STAFF REPORT

DATE: 1/2/24

TO: Lake Elmo City Council
FROM: Nathan Fuerst, AICP, Consulting Planner
AGENDA ITEM: Bridgewater Village Preliminary Plat, Rezone, Conditional Use Permit, Comprehensive Plan Amendment,

TREE PRESERVATION PLAN

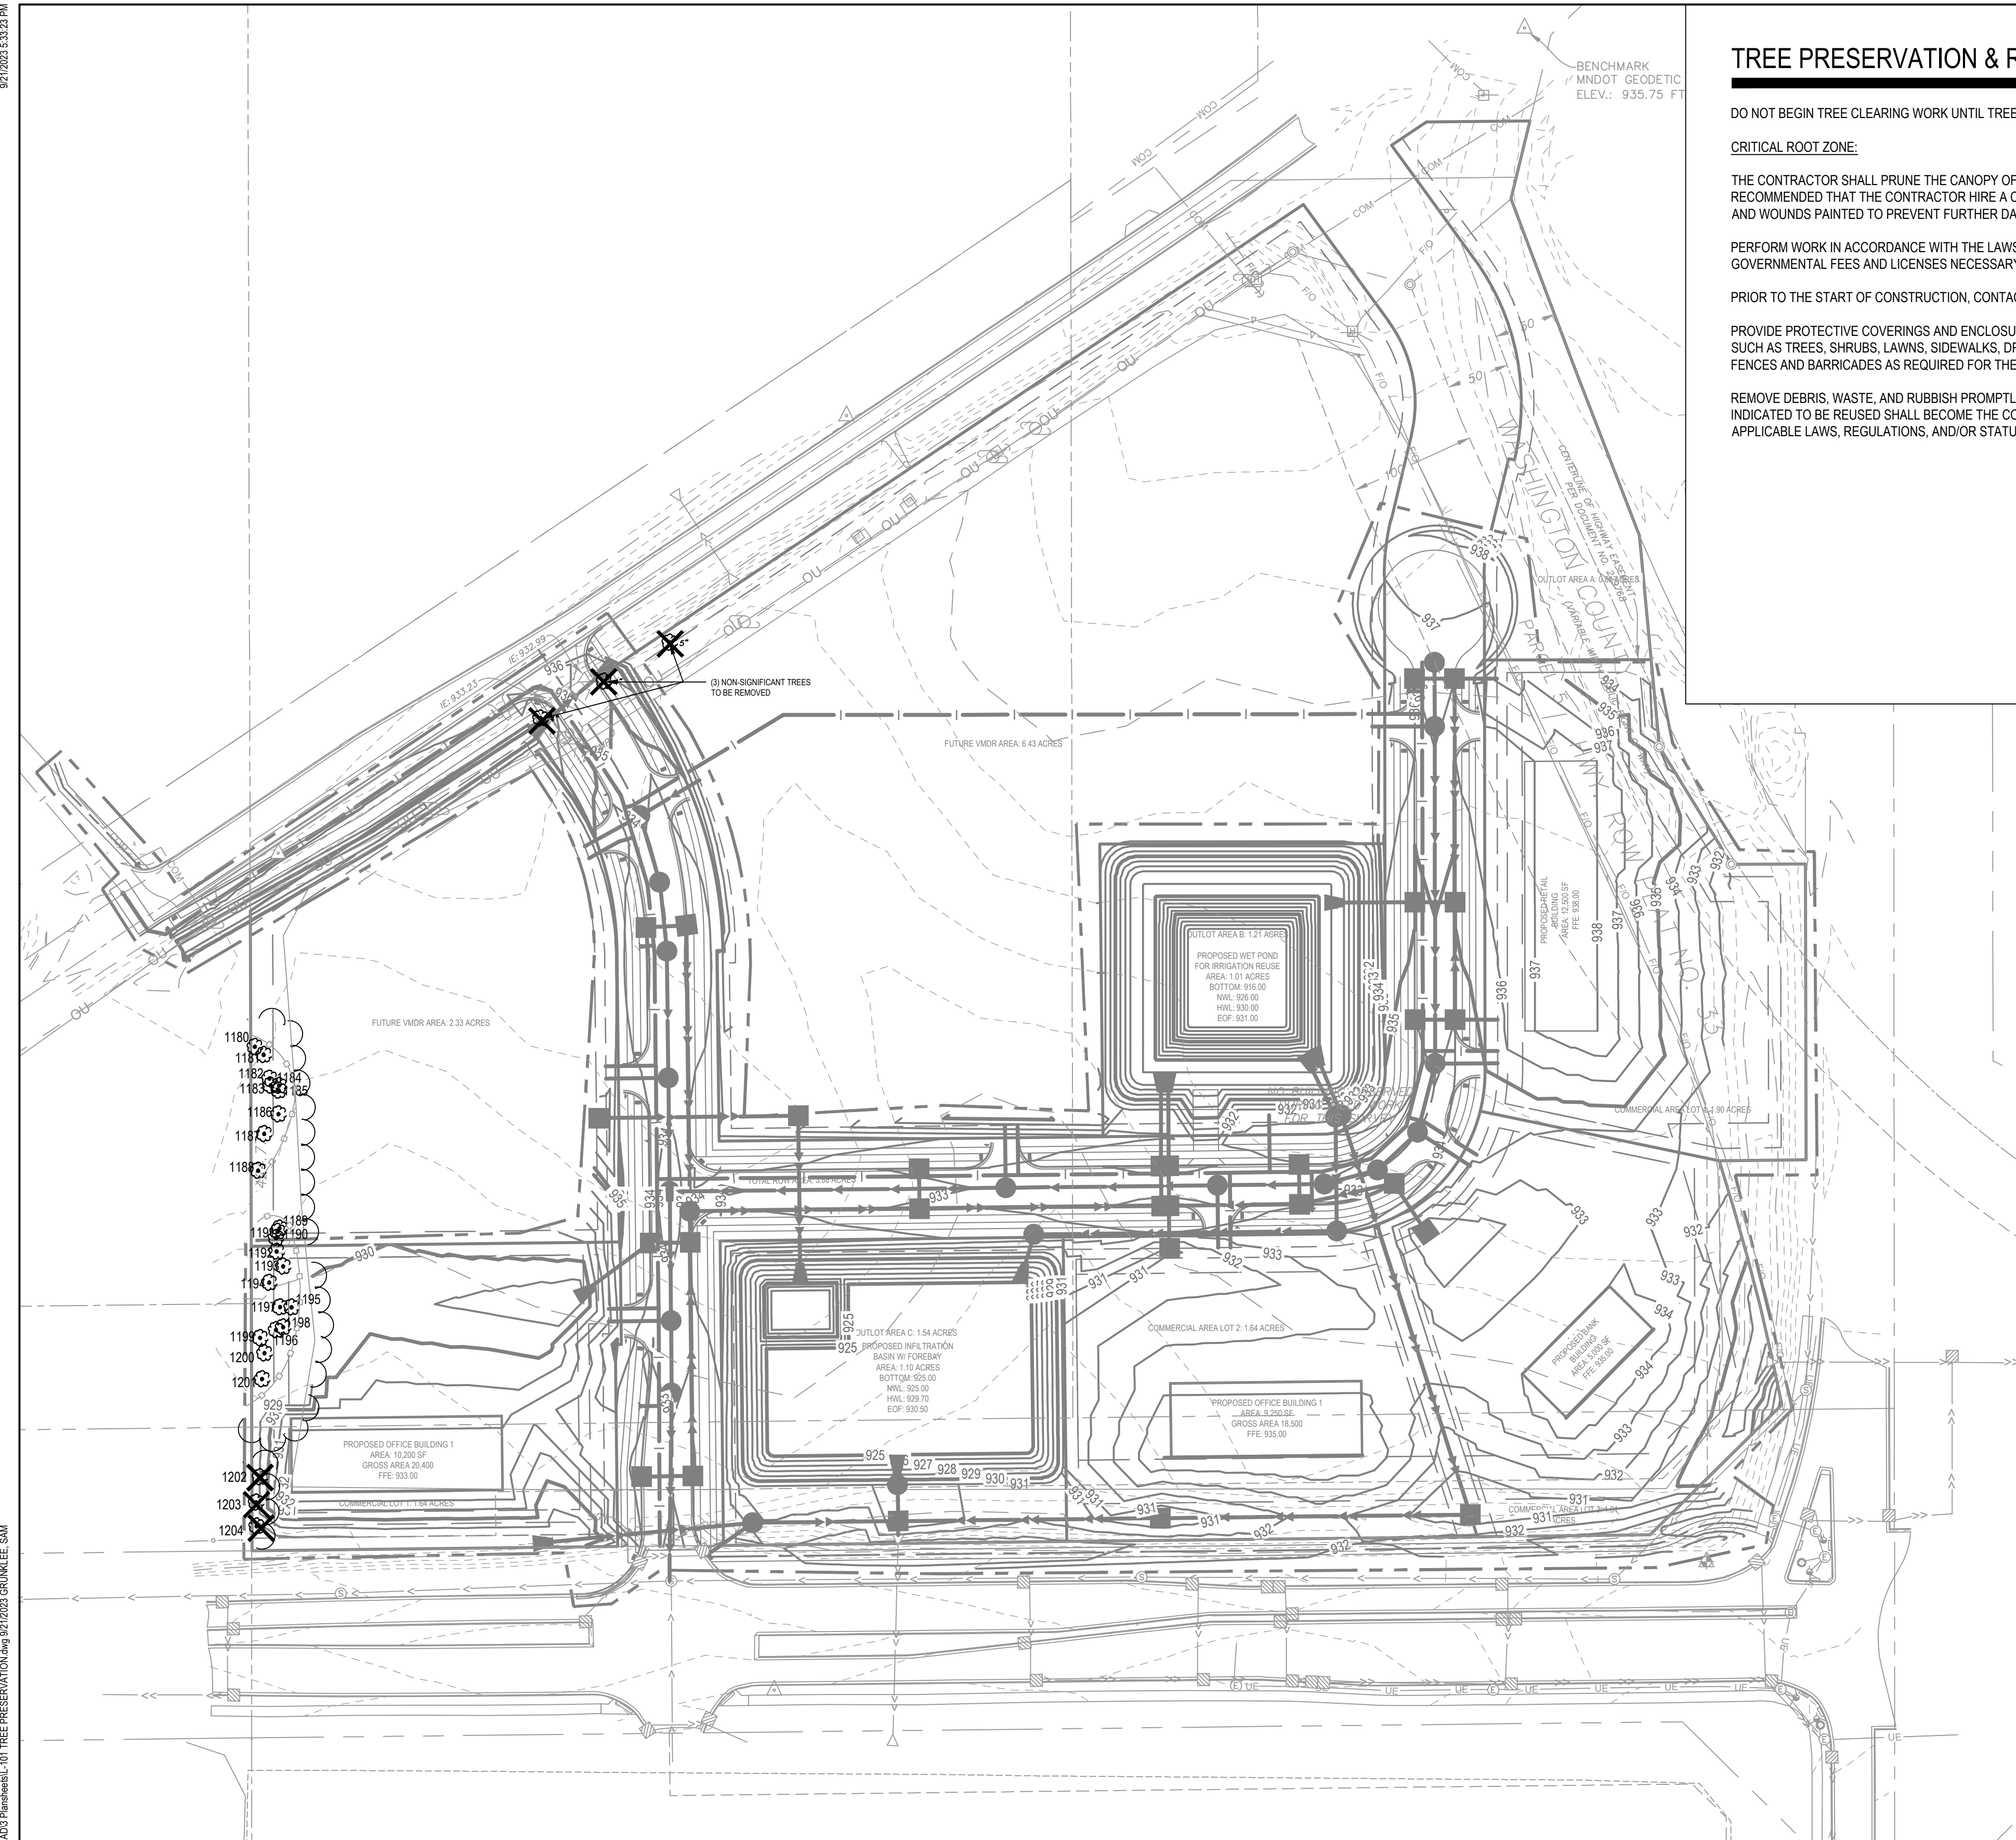
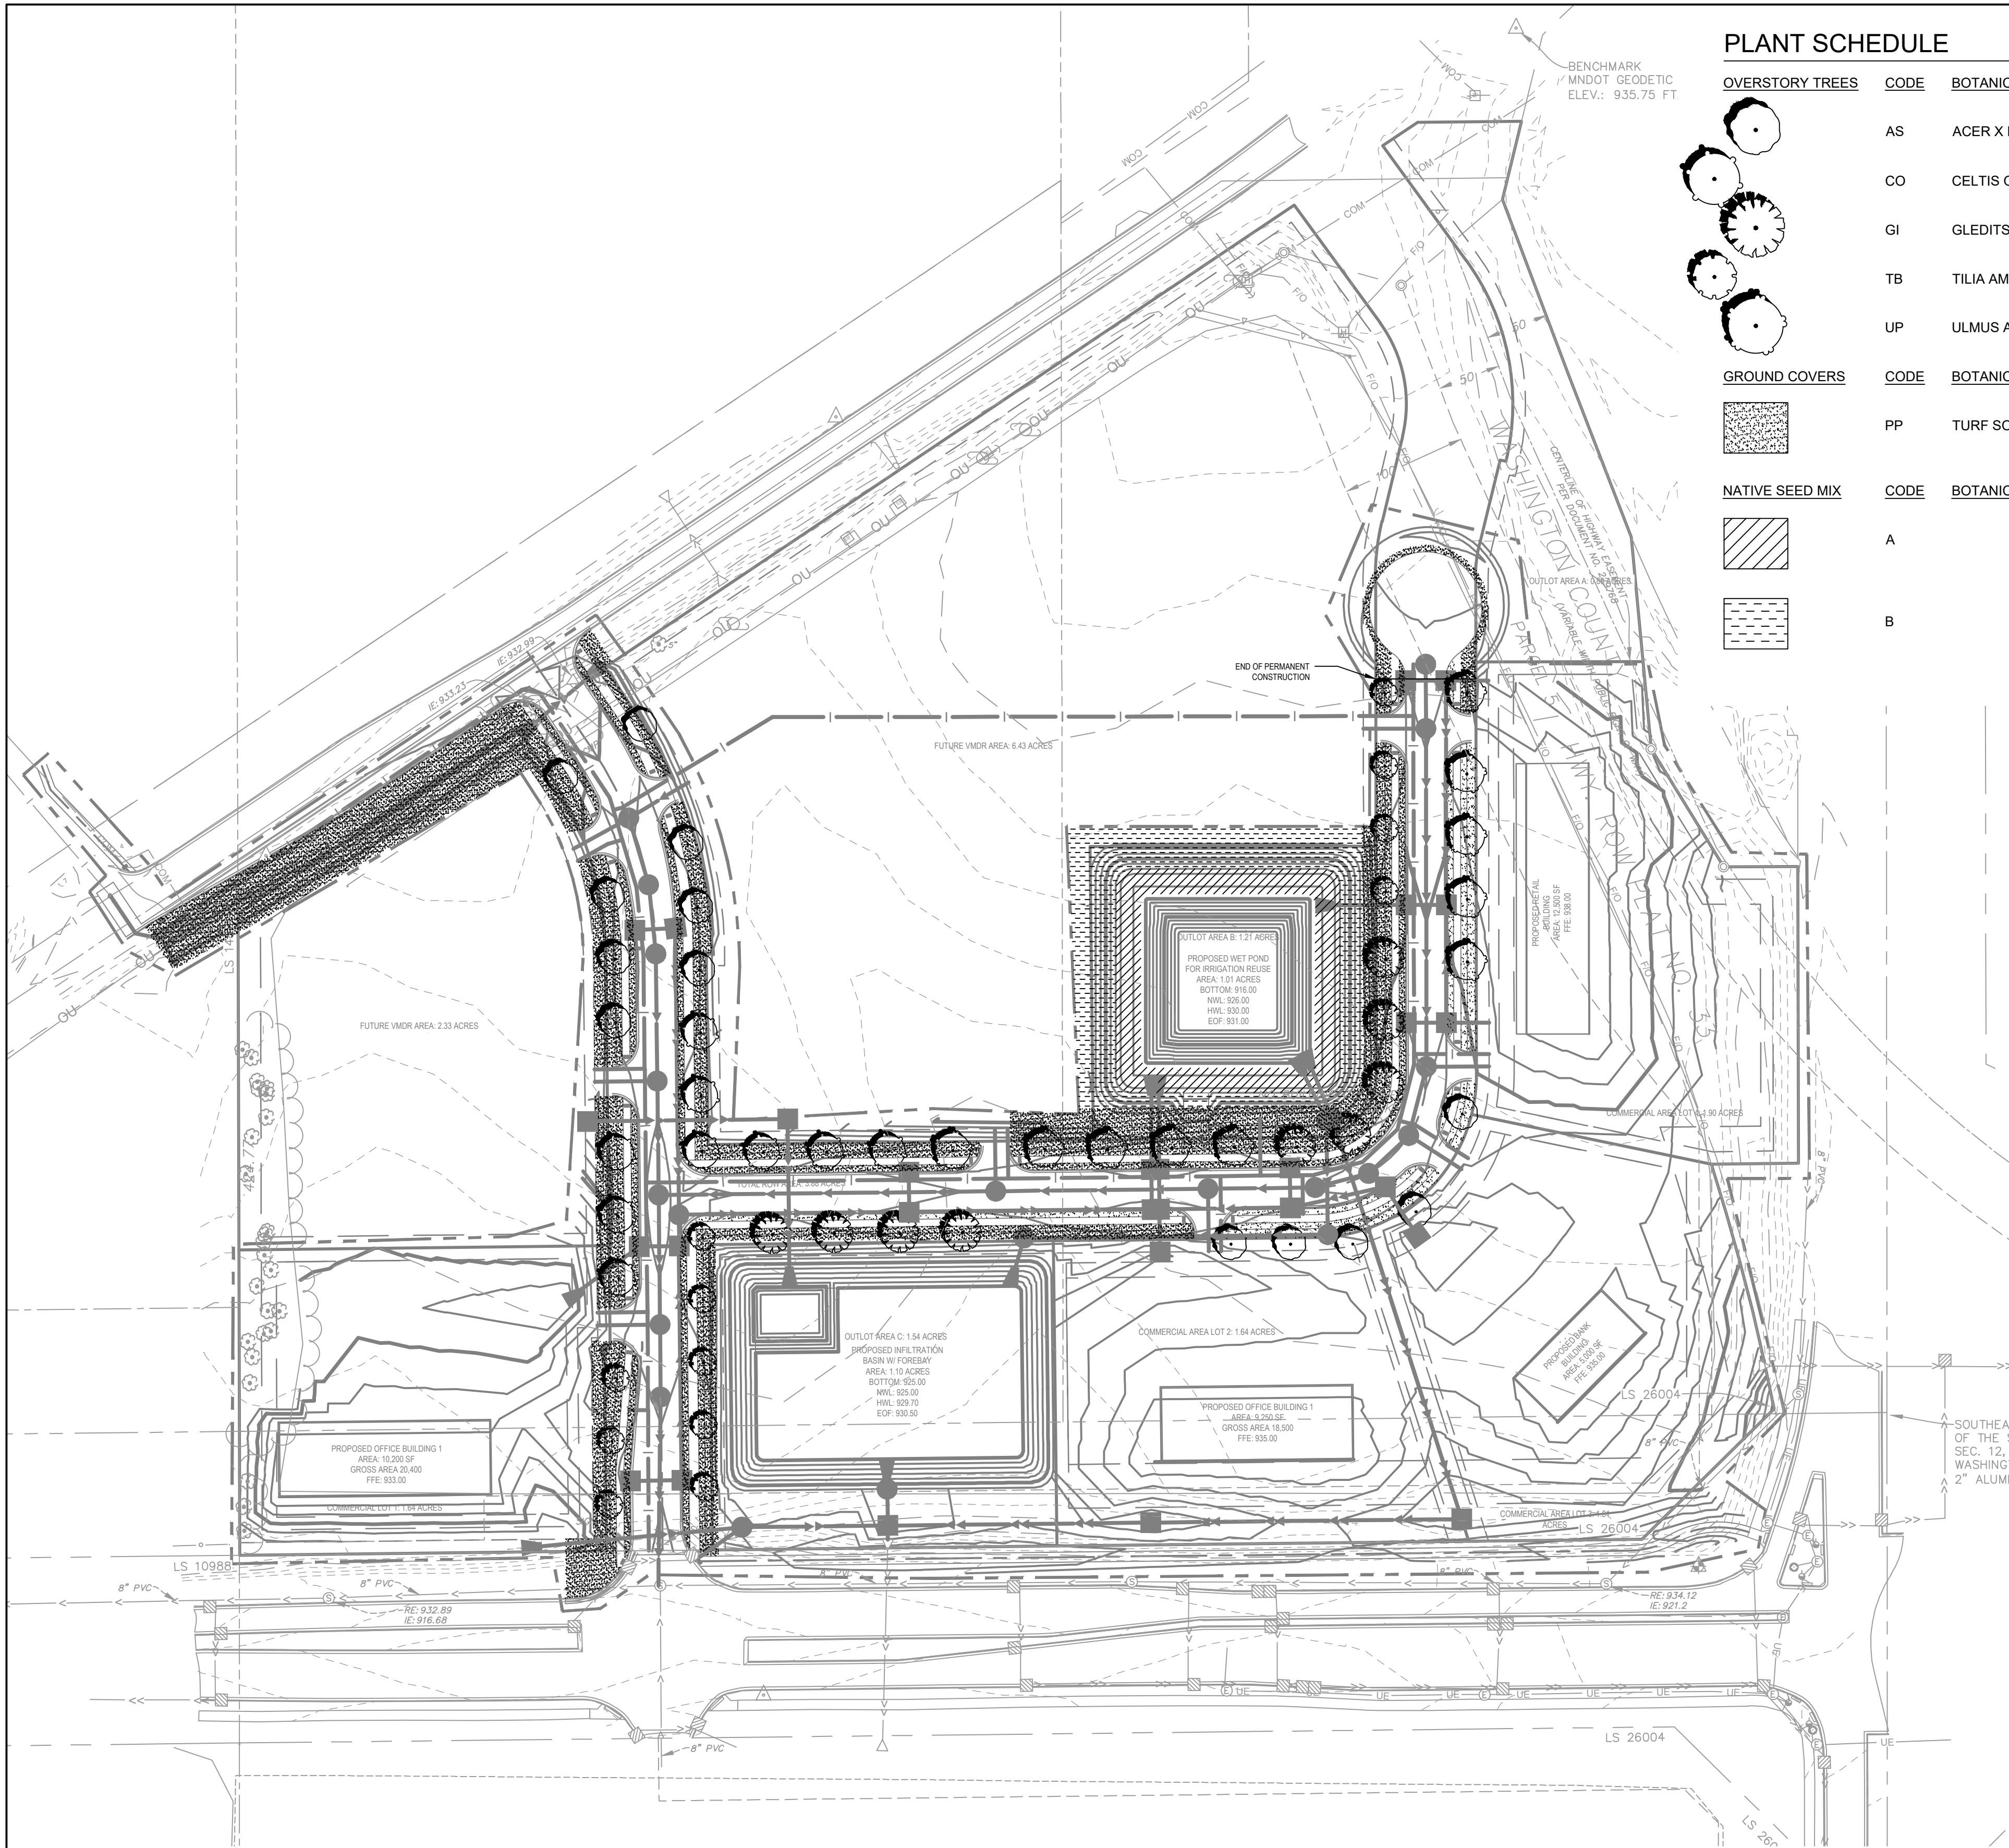
Landscaping and Tree Preservation: The Landscape Architect is suggesting revisions to the submitted tree preservation and landscaping plans as a condition of preliminary plat approval. Trees required in the area of disturbance shall be identified and provided on the plans. Boulevard plantings are required at the time subdivision improvements are installed.

3. Prior to the City finding any application for the final plat to be complete, the Applicant must revise the landscape plan and tree preservation plan in accordance with the City Landscape Architect's memo dated October 9, 2023 to the satisfaction of the City.
